DISCOVERY
CHILDREN'S
MUSEUM

NOV 2015
SDR-40146
LAI REVISED

RE: SDR-40146 – SITE DEVELOPMENT PLAN REVIEW
CITY COUNCIL MEETING OF JANUARY 5, 2011

- 1. Sheet GA2.01- the circulation of the ground level shown in the revised garage is confusing and creates conflict points for patrons. Please modify. Also the planters shown on the Promenade Place sidewalk extend too far into the sidewalk and reduce the pedestrian space well below the 10 foot minimum required. Please reduce the size of the planters to the build-to-line.

SHEET TITLE
EXTERIOR ELEVATIONS

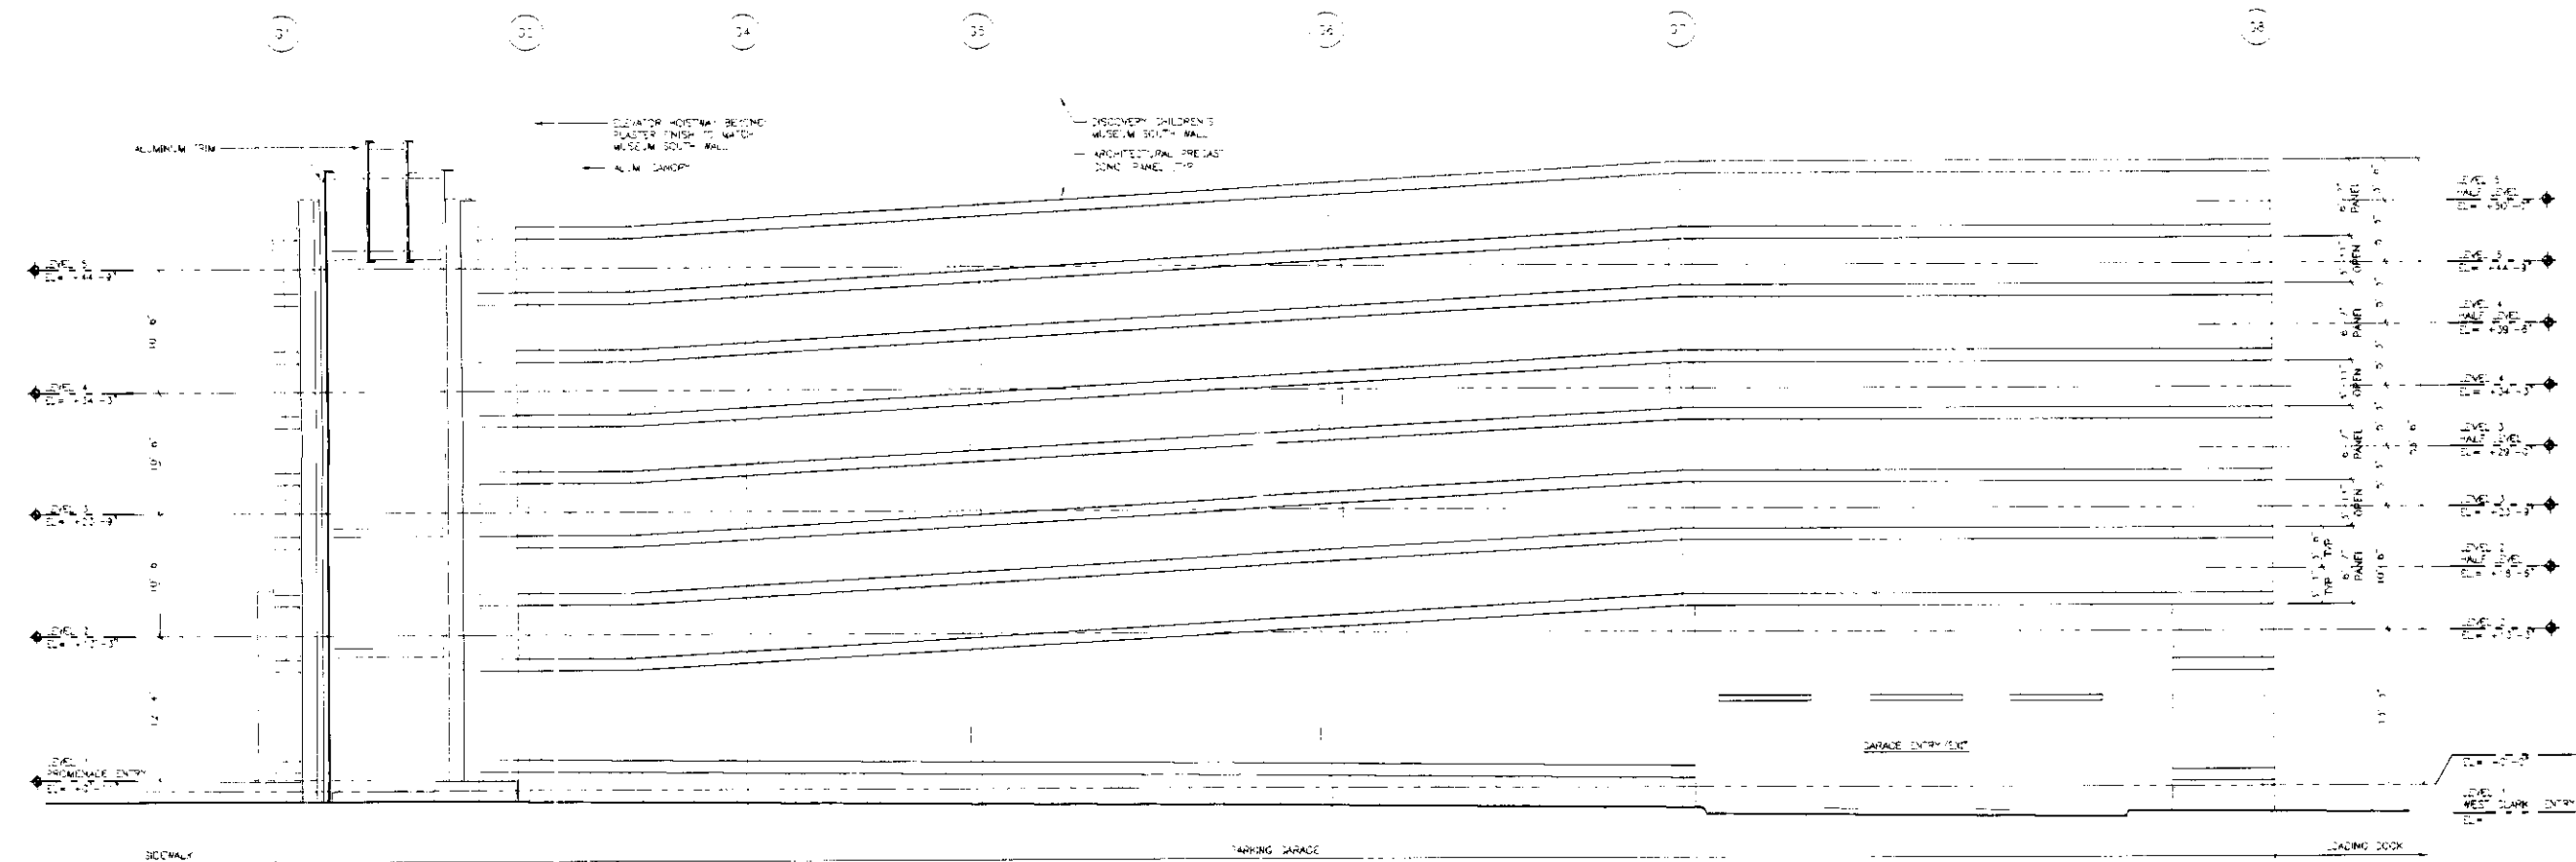
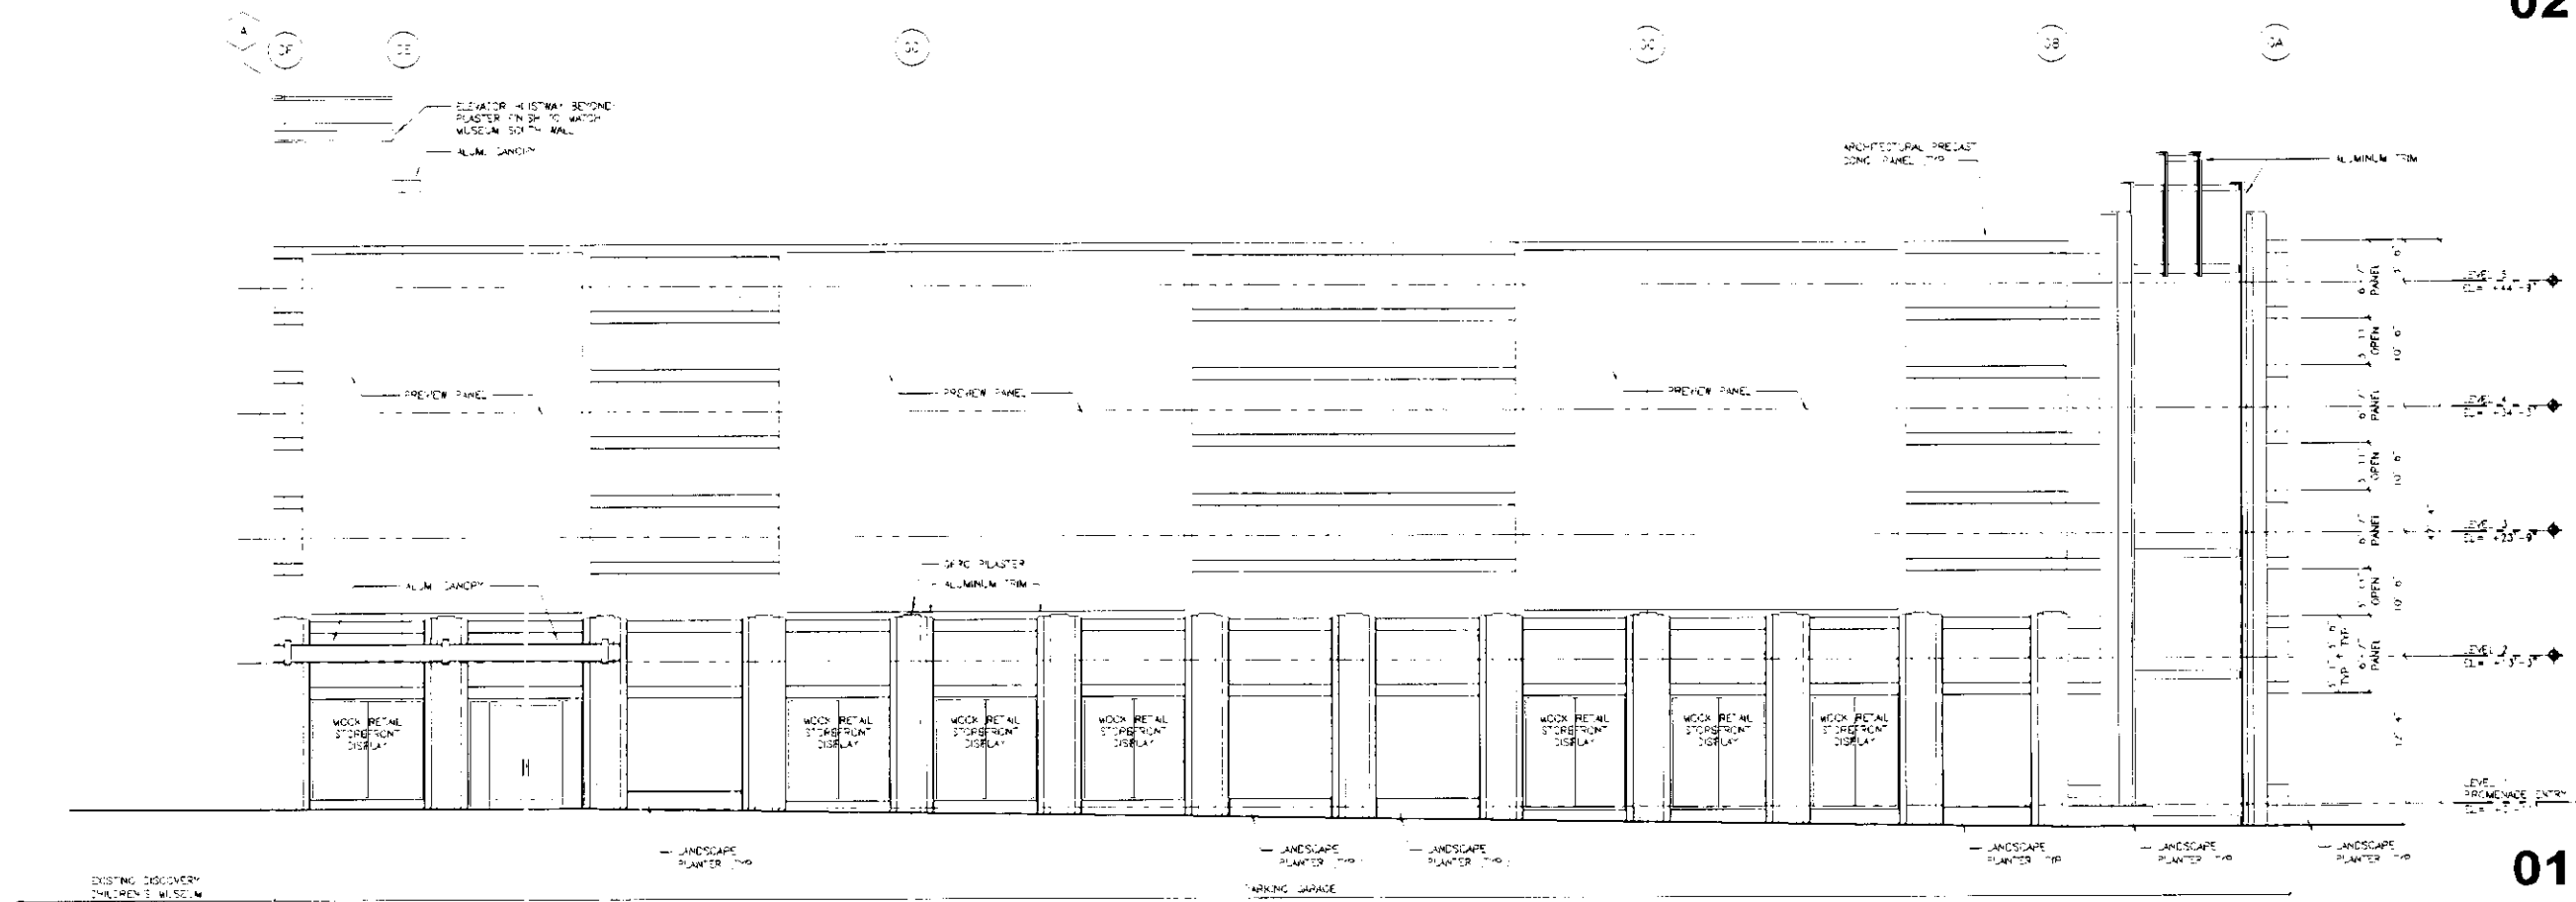
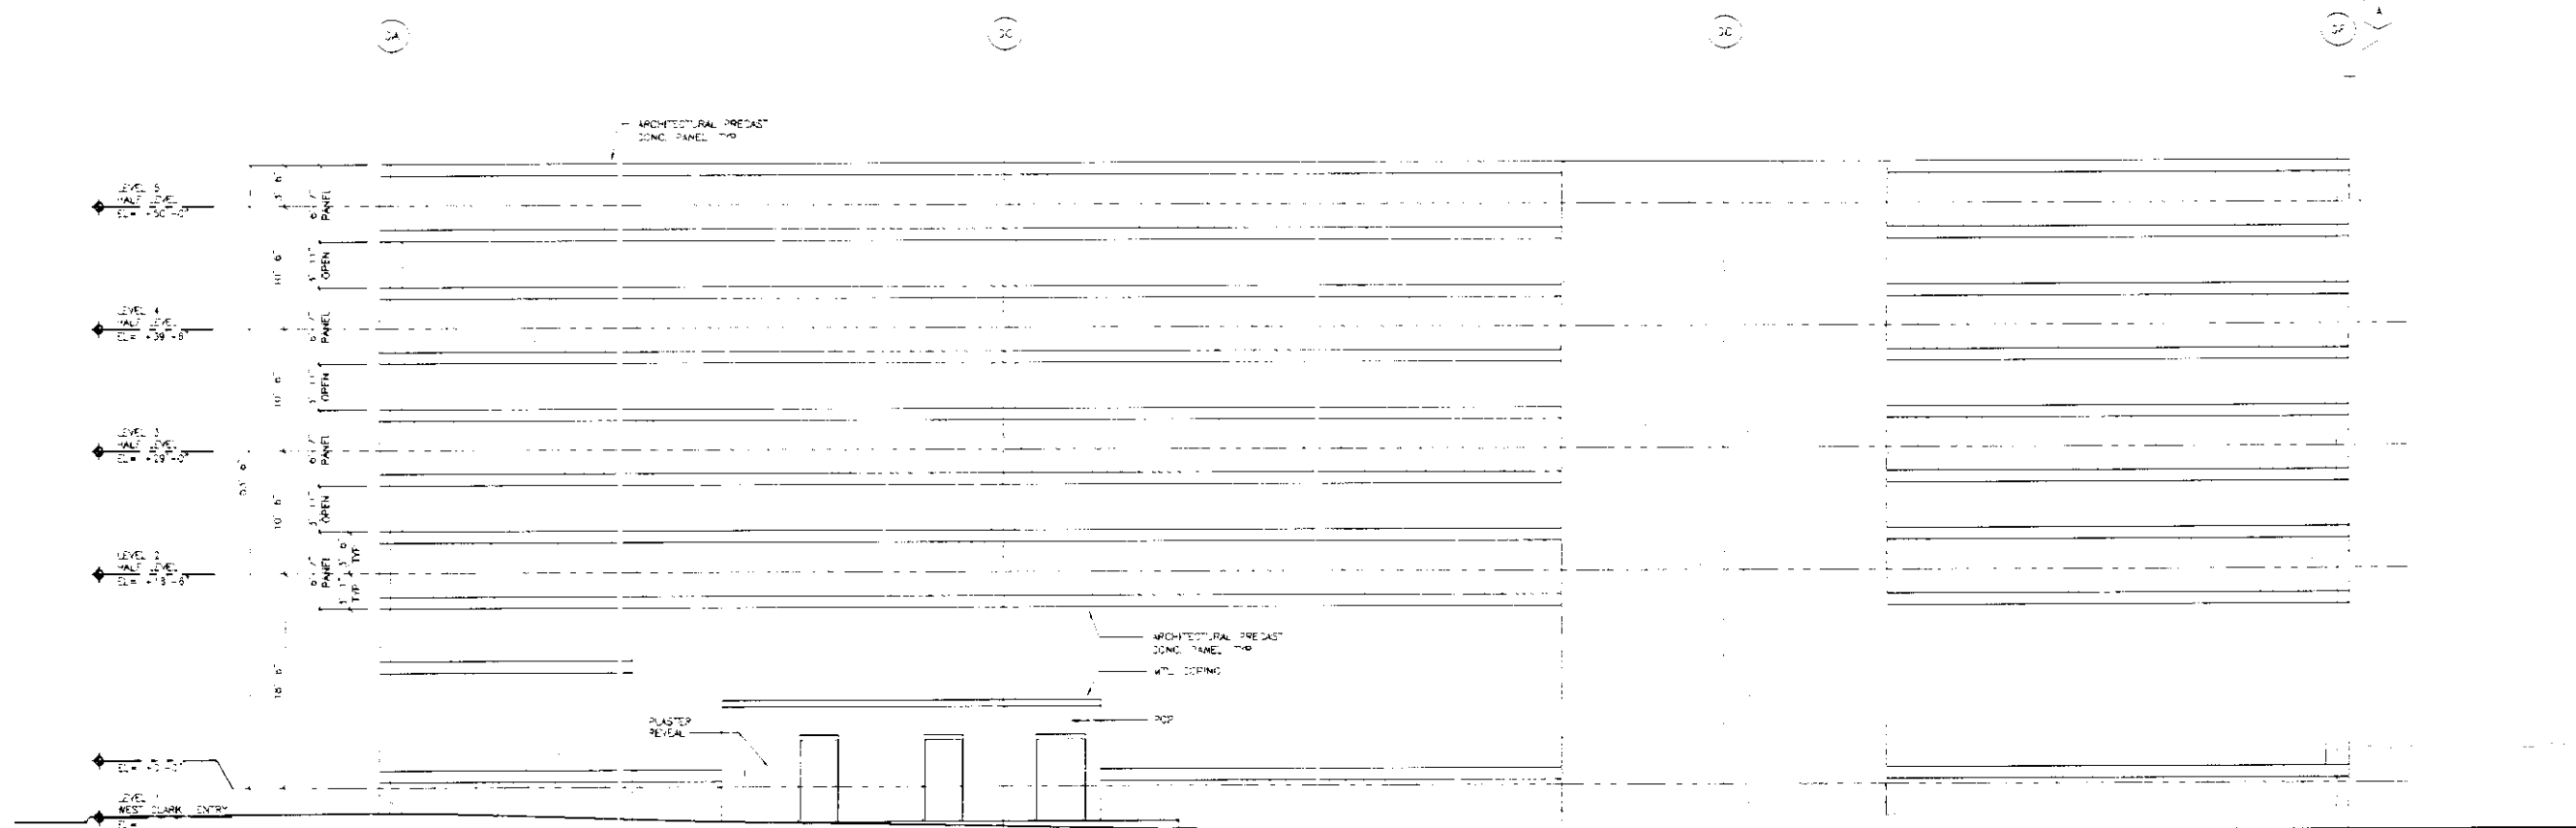
4. Please indicate on the GA5.01 Exterior Elevations the location of required mesh screening along Promenade Place and Clark Avenue as per Amended Conditions of Approval No. A of SDR-40146 for screening parked vehicles and sloping floors from view.
5. Please provide evidence of a Cross Parking Agreement in accordance with SDR-16267 and the Parking District Plan for Symphony Park.

1. The Garage elevations shown on Sheet GA5.01 do not reflect any of the last set of comments from the SP-DRC and are found to be lacking the quality of architecture required for them to be approved per the Design Standards. If approved anyway, the following Sections of the Required Design Standards would have to be waived, presented here with a parenthetical note of how the current project responds.
 - a. Section 1.5.1 – Active Frontages along the Promenade are required (none provided).
 - b. Section 1.5.3 – Active Frontages along West Clark Avenue required (none provided).
 - c. Section 1.5.5 – Retail and restaurant frontage on Promenade Place is required (none provided).
 - d. Section 1.6.4 – Exposed Parking on Promenade Place shall be avoided (parking is exposed). Parking shall be minimized, and

- 2. Sheet GA5.01
 - a. Provide canopies along the rest of the Promenade Place elevation over the display openings.
 - b. Provide an architectural treatment on the West Clark Avenue elevation similar to the Promenade Place elevation

SHEET NO.
 12887.000
 DATE
 11-22-10
 SHEET
 PARKING GARAGE
 REVIEW
 SHEET NO.
 L3.01

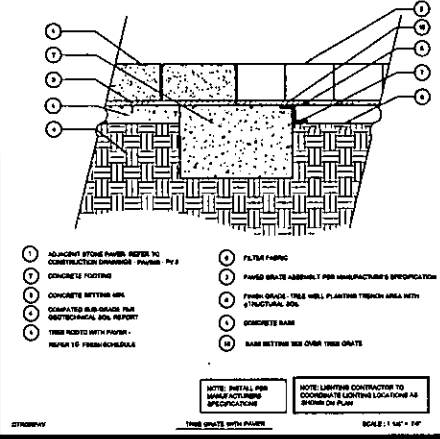
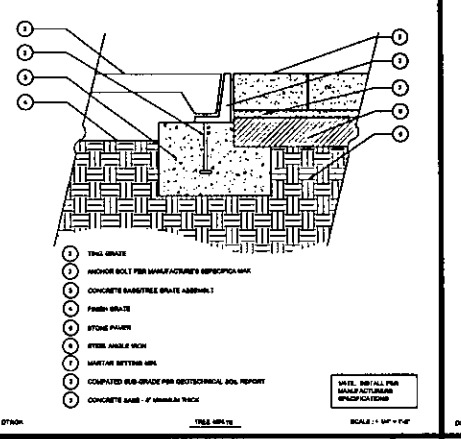
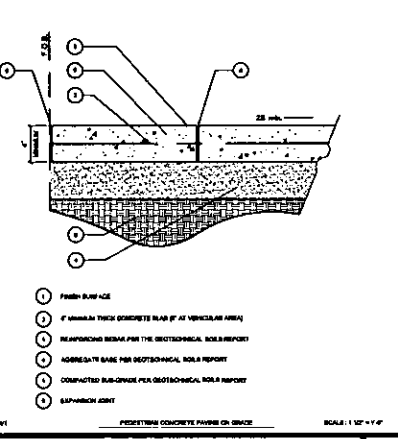
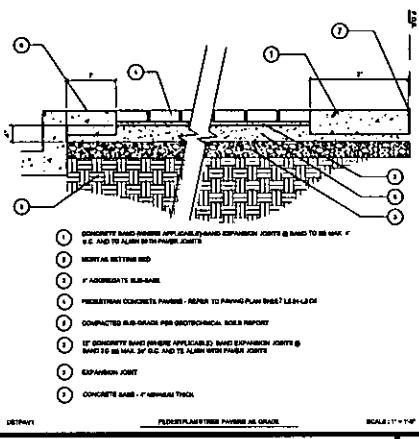
4. Sheet L3.01 – Detail D needs the addition of a WWF reinforcing note and clarification of the reference to sheets L5.01-L5.06 that are not included here for review.

THE PROJECT NUMBER
12887.000
DATE
11-02-10
SCALE
3/4" = 1'-0"
SHEET TITLE
LANDSCAPE
PLANTING
DETAILS
SHEET NO.
L8.01

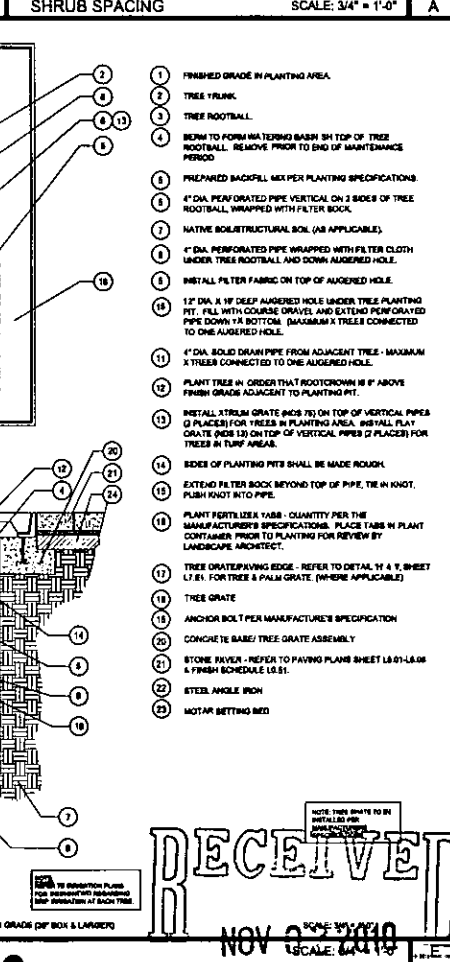
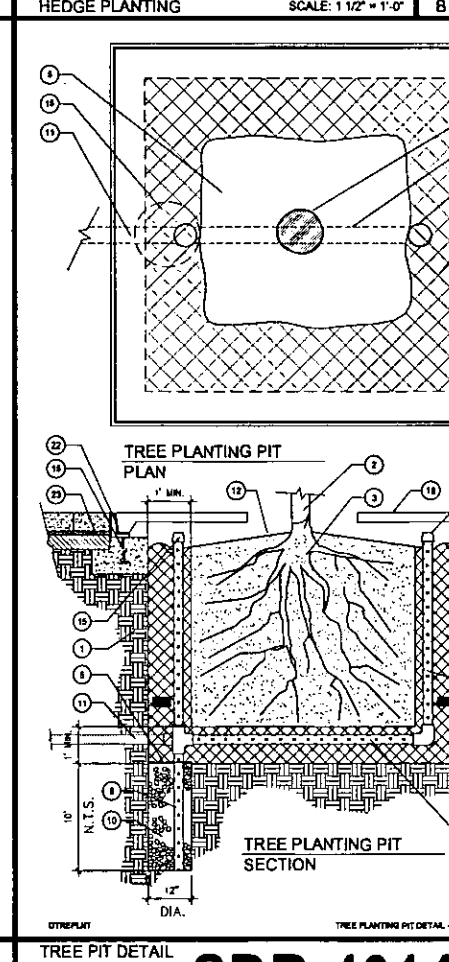
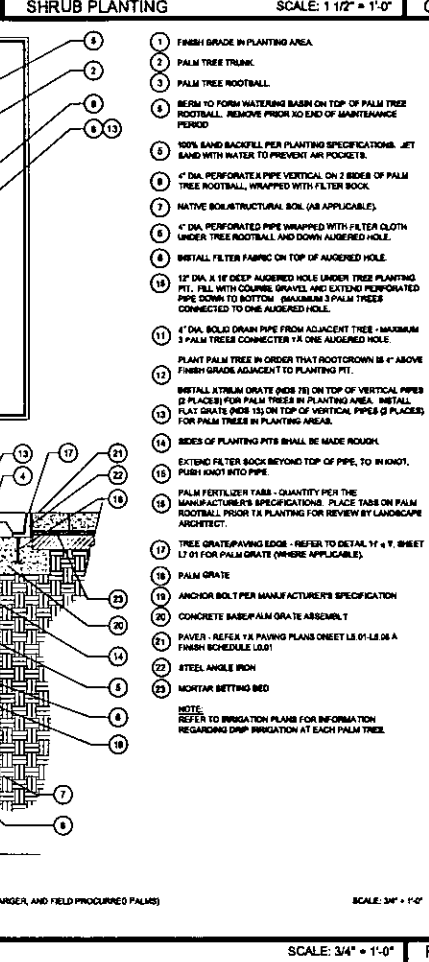
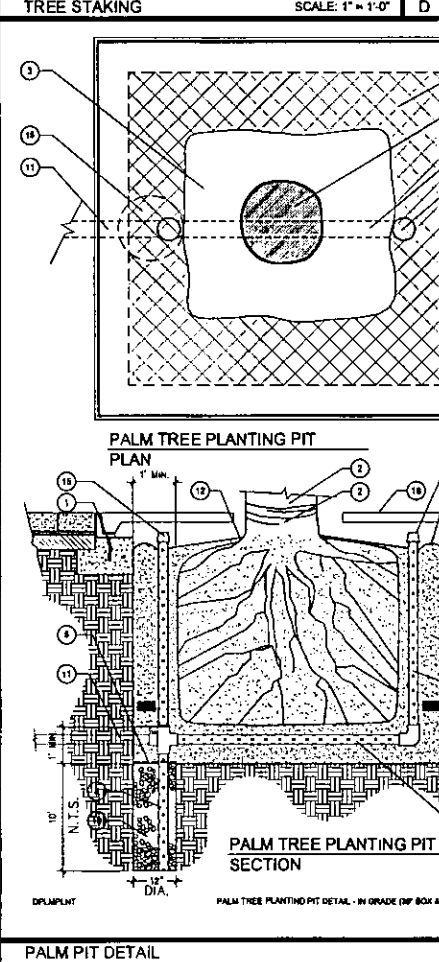
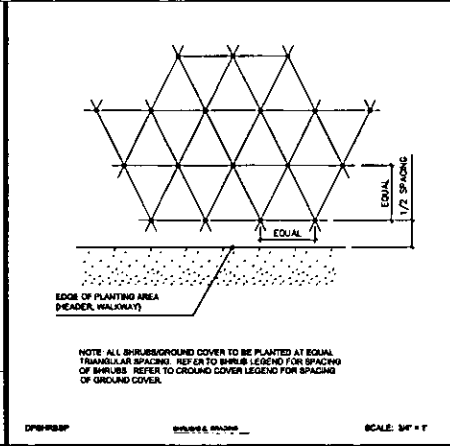
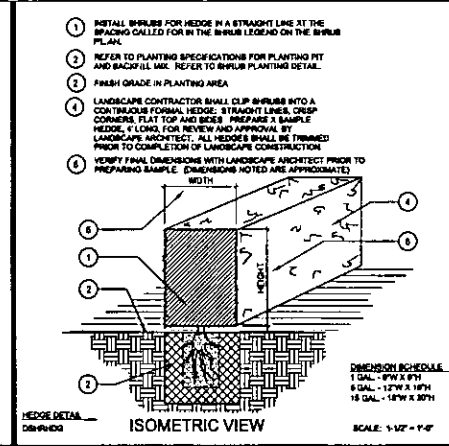
8. Sheet L8.01 – Two additional details are needed – one for a continuous tree trench and one for a metal support system for the Italian Cypress.
9. Sheet L8.02 – Detail B needs to be modified to indicate 22 feet as the BTH on the Palm instead of “Height Varies”.
